TAMF4-2016-019

Memo # 0019

## SAFETY

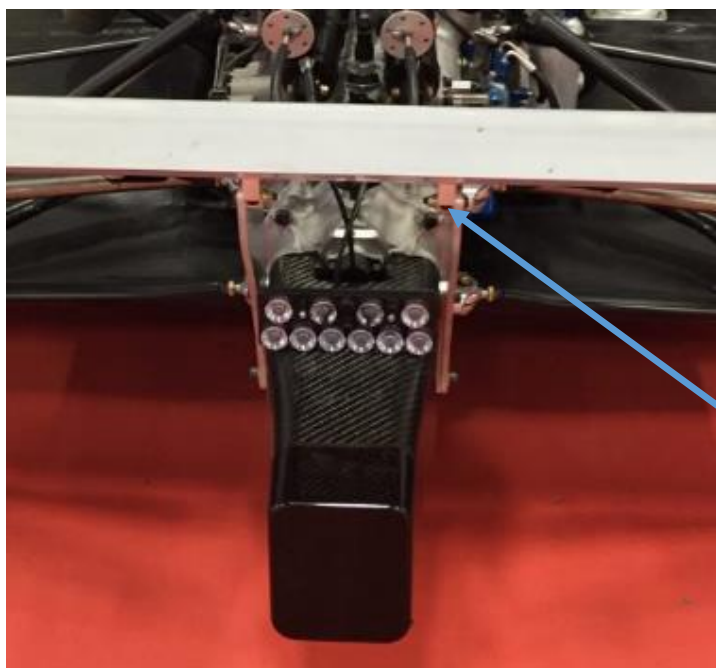
Teams testing currently or imminently should take extra care in checking the rear wing assembly, taking particular care to check the bolts holding the mounting brackets to the lower main-plane – see picture below.

Vertical bolts into  
main-plane - check
